# US 1/SR 4 Widening and Oak Park Bypass

EDS-545(14)(17)(18) Toombs and Emanuel Counties

## Value Engineering Study Report Preliminary Design Stage

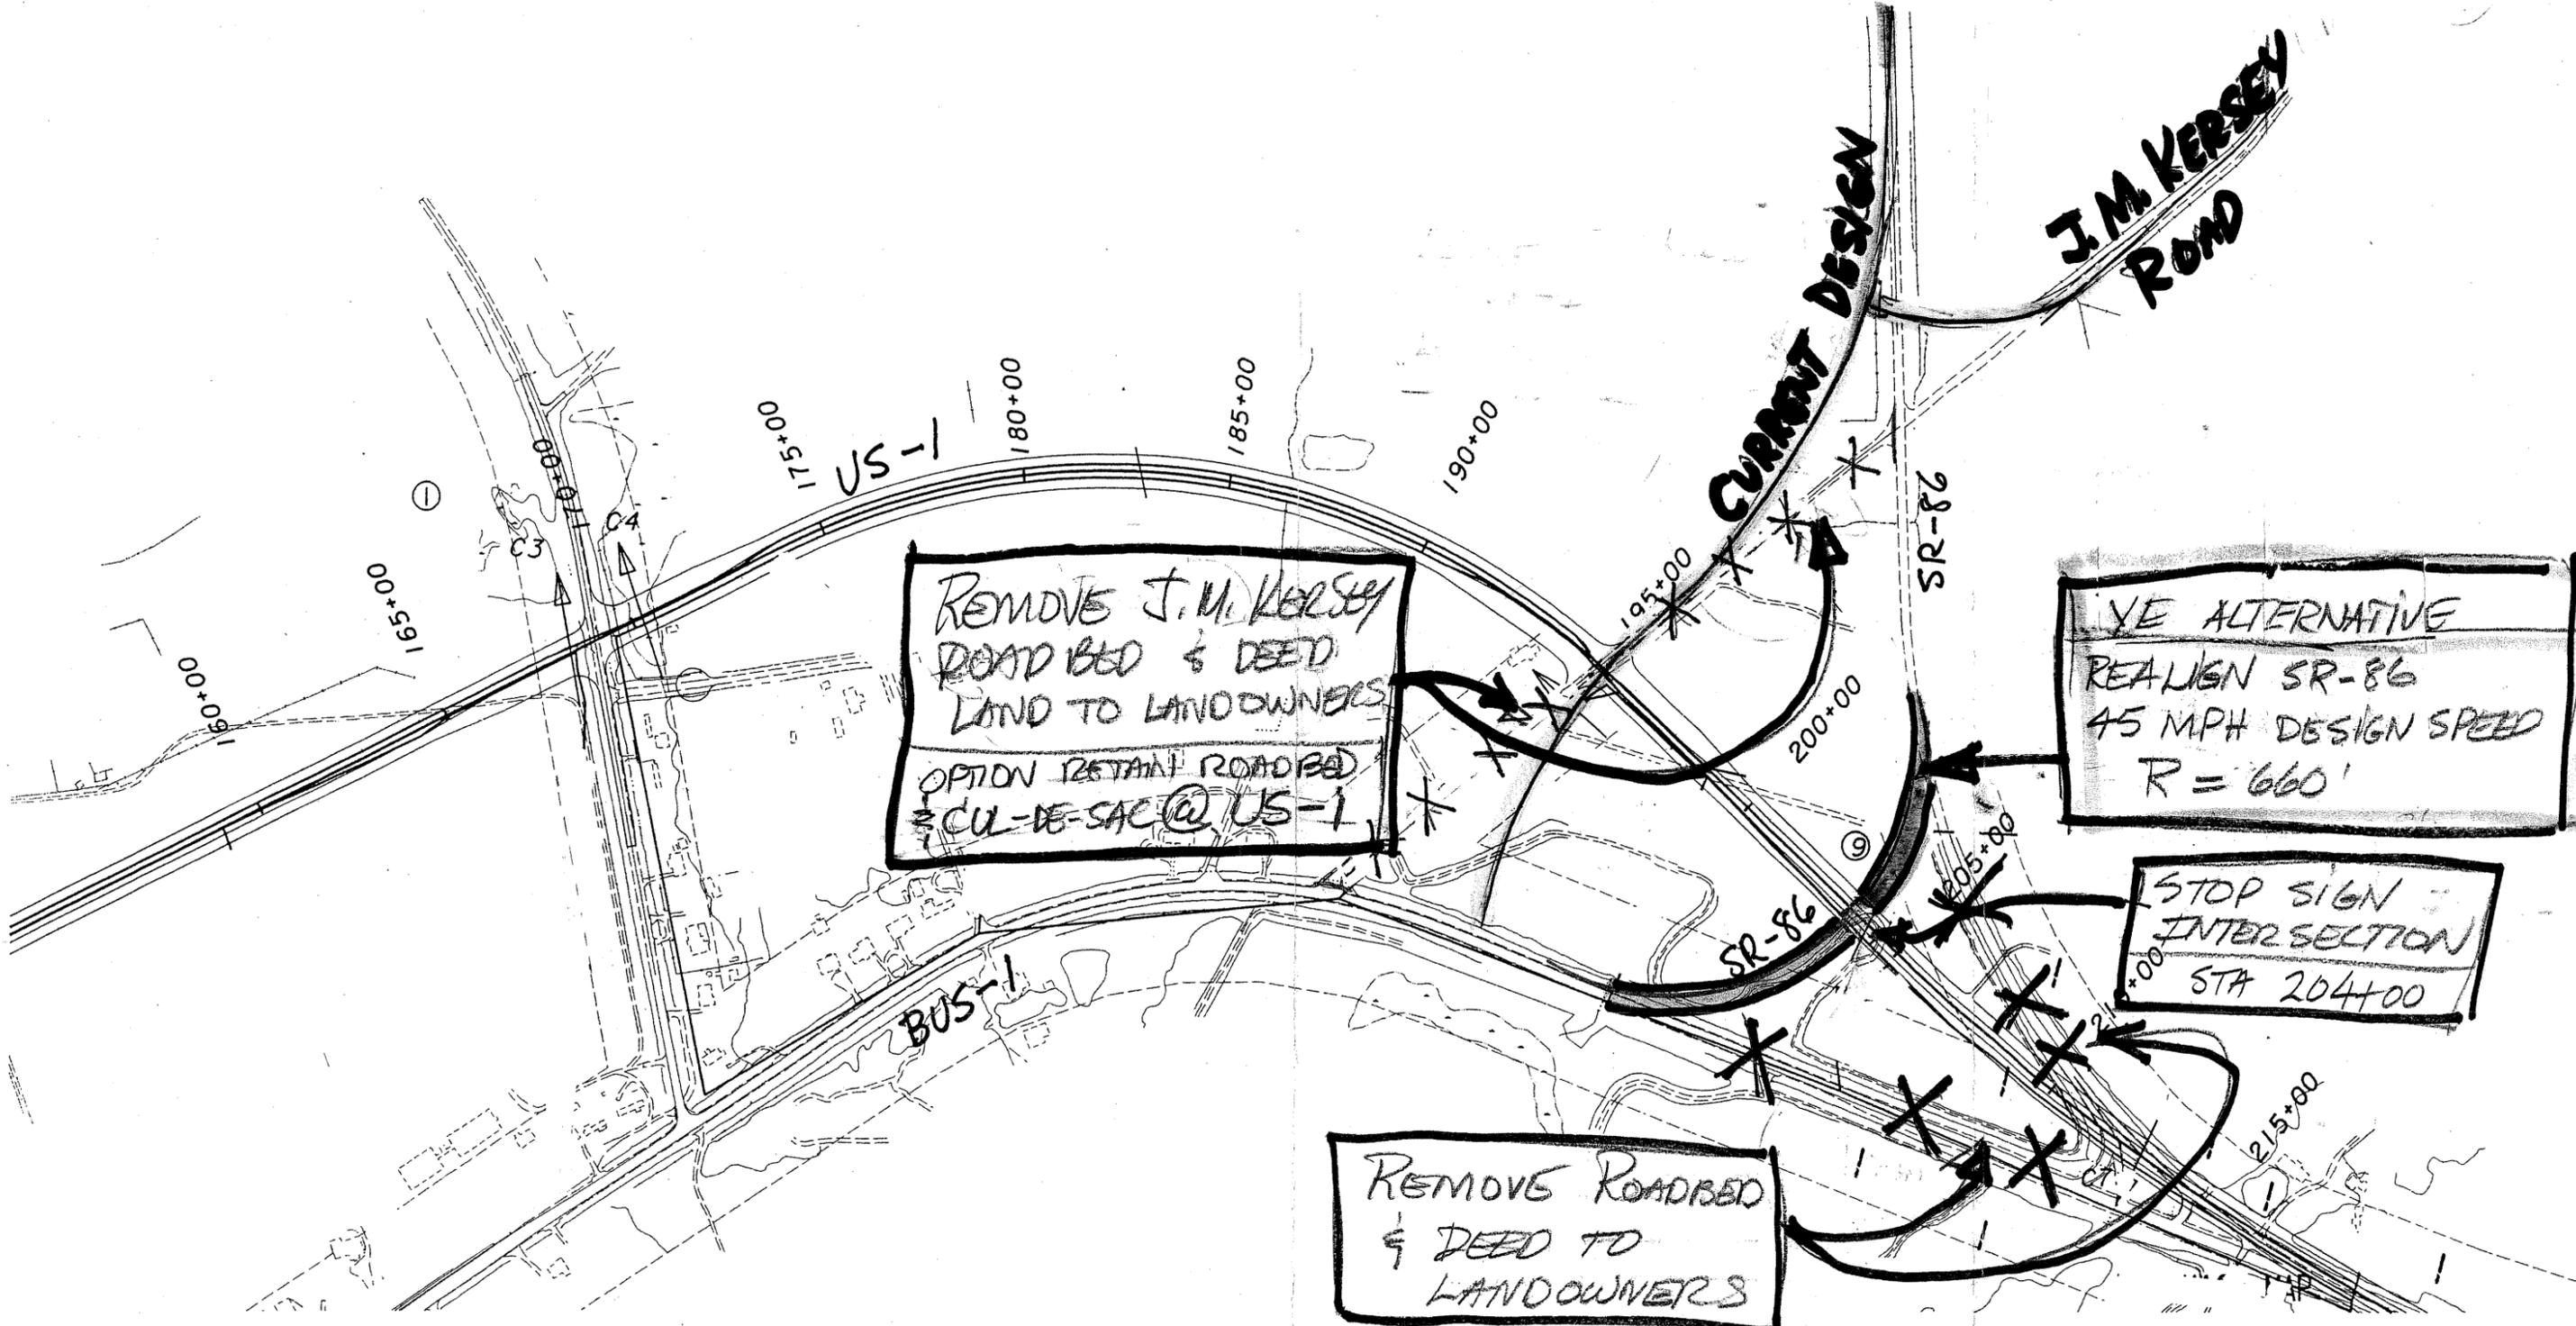
- Uninterrupted US 1/SR 86 (N) flow
- Less roadway realignment
- Less right-of-way impact
- Increases development potential for the north end of Oak Park
- Possibility to retain portions of the J.M. Kersey Road

→ REMOVE JIMKESSEY RD → NO CHANGE BETWEEN TWO OPTIONS

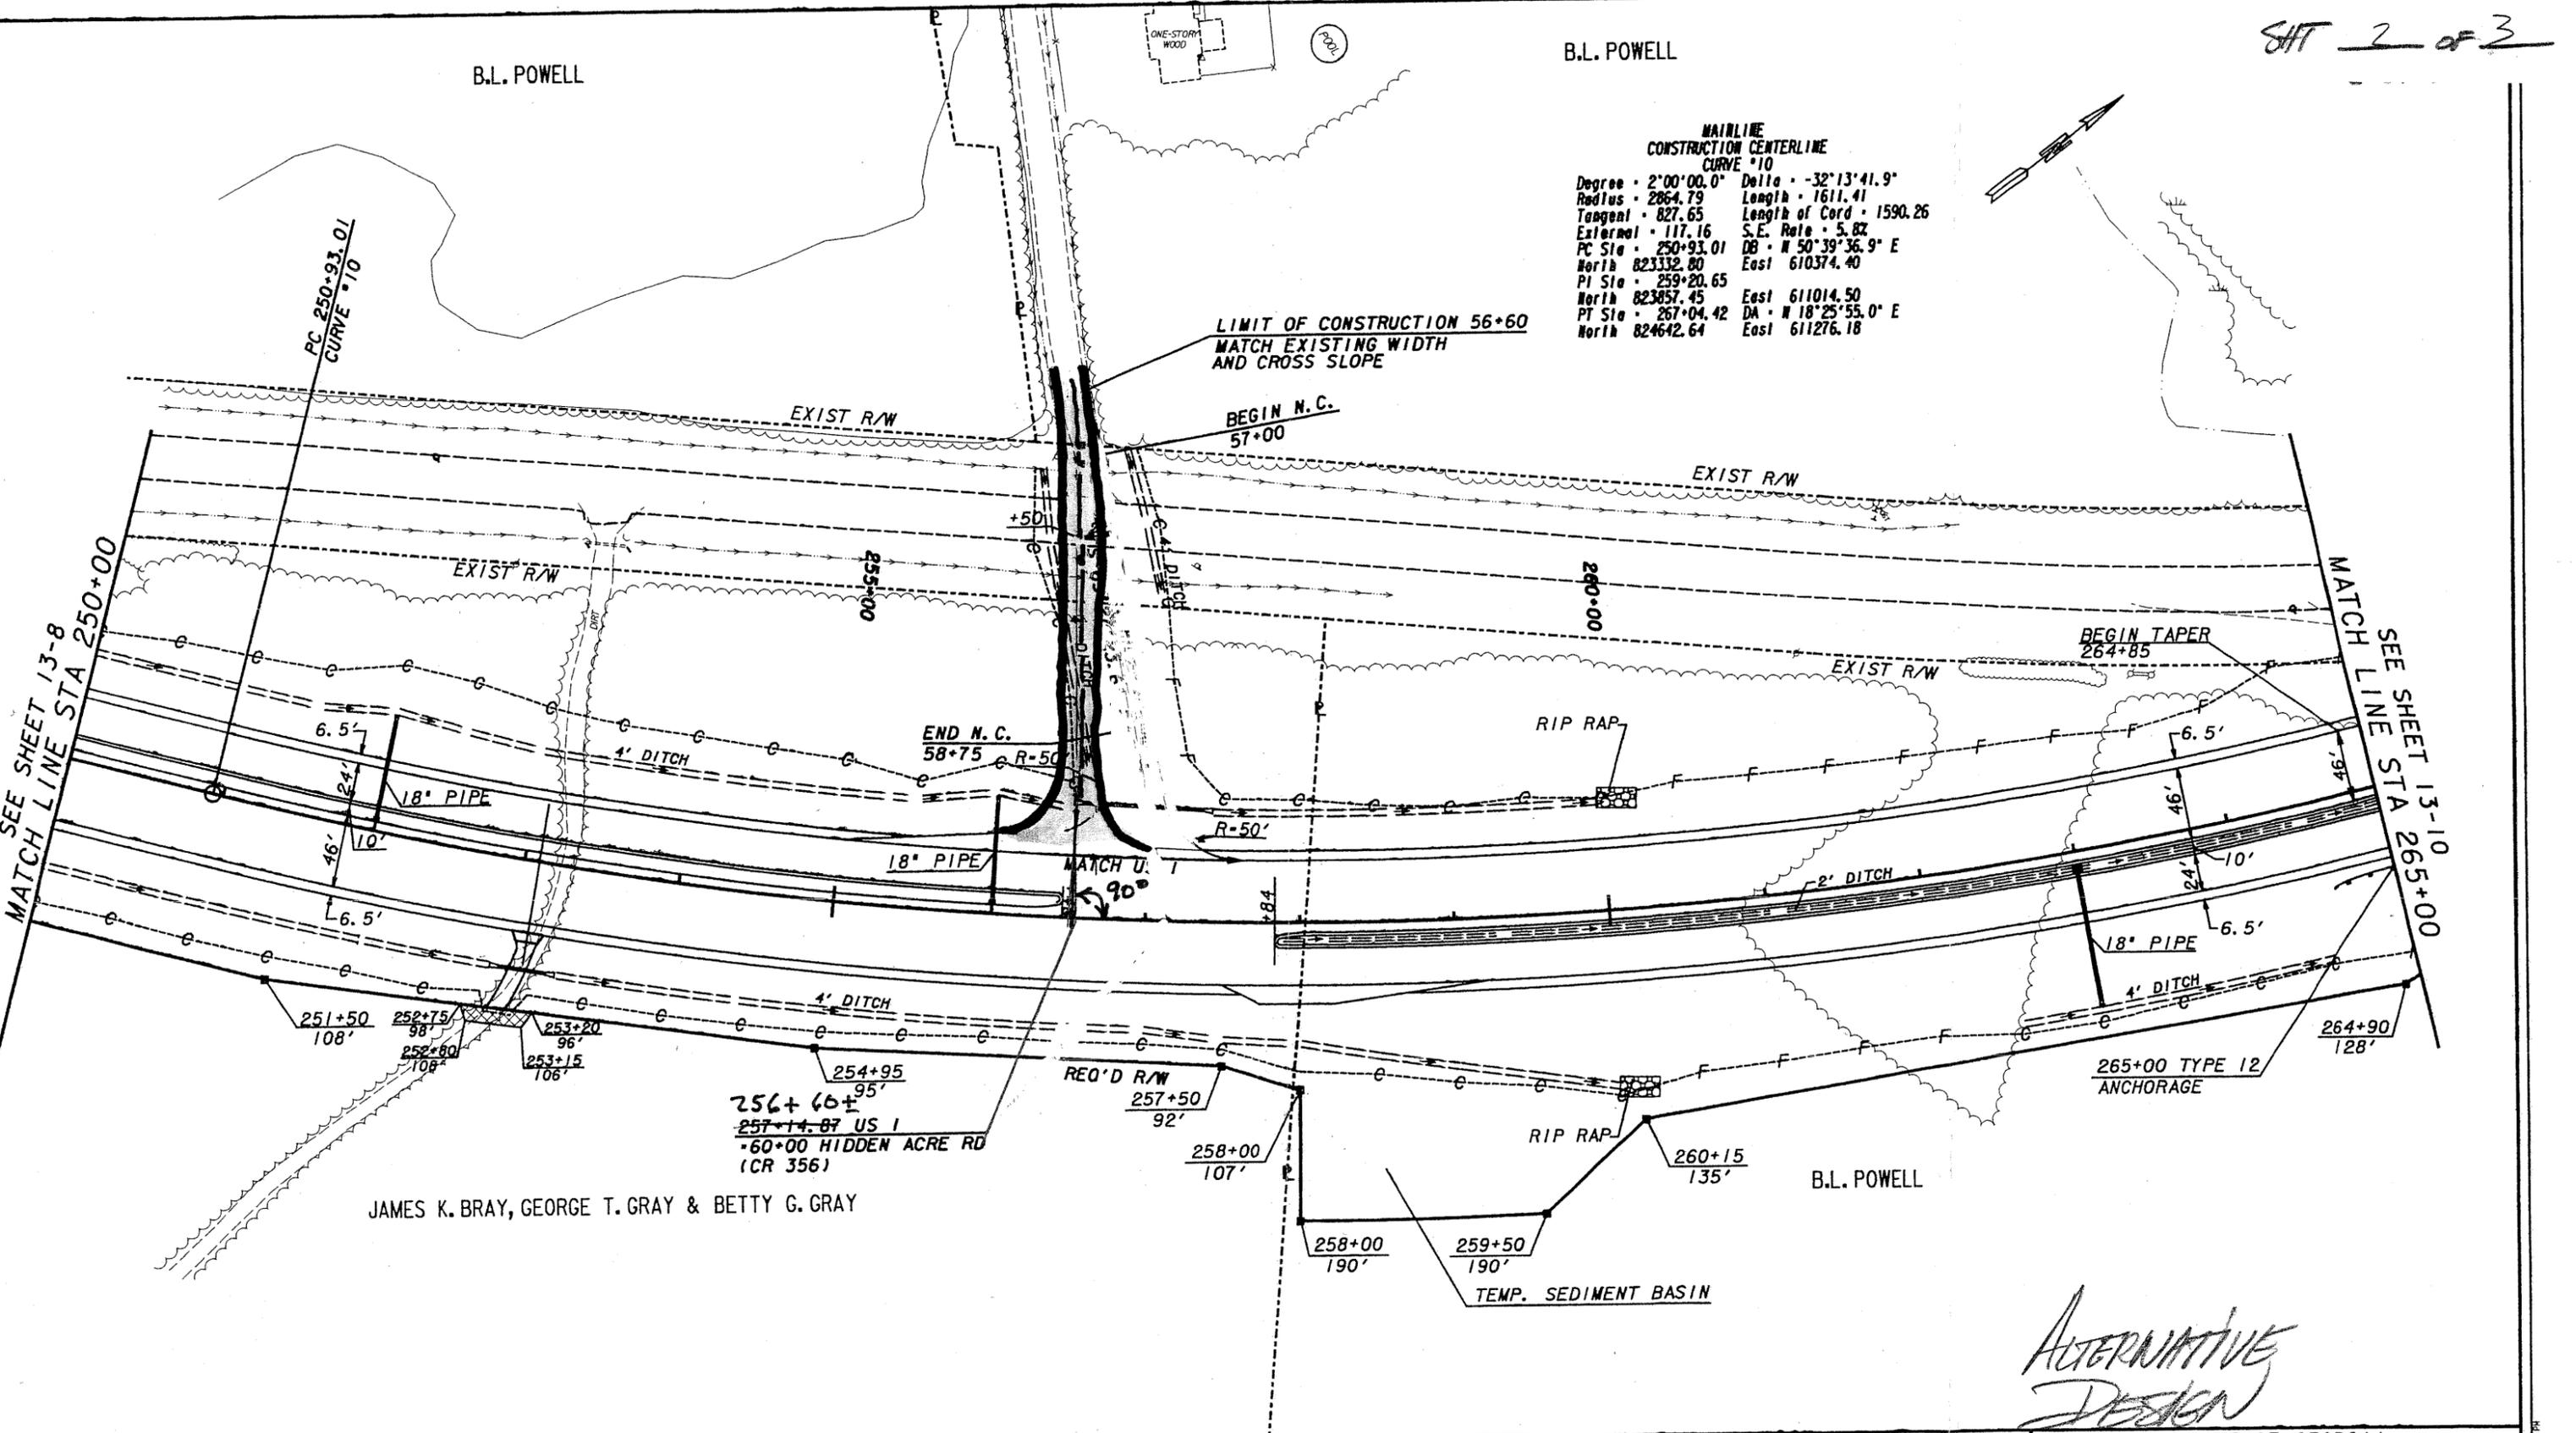
Shifting Hidden Acre Road to south does not impact cost and is a logical way to intersect the “T” approach of Hidden Acre Road and US 1.
